This page lists the know errors on the gm5x5x5 PCBs. There are no known issues with the bulk order run (white pcbs), the following information is valid **only** for the prototype run (green pcbs).

Prototype Run

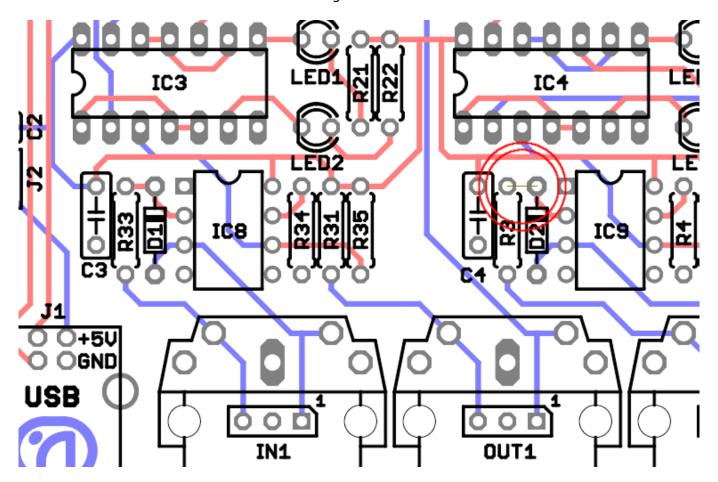
#1 MIDI IO pins

Problem: The MIDI IO pins of the midi sockets (Pin 4 + 5) are switched.

#2 MISSING TRACK

Problem: A track between D2 and R3 is missing.

Solution: Either (1) use the pin-headers if you use sockets that are not mounted on the pcb or (2) break the traces to pins 4 + 5 of the sockets and solder wires to them or (3) solder the midi sockets on the other side of the pcb.

Solution: Bridge the pins.
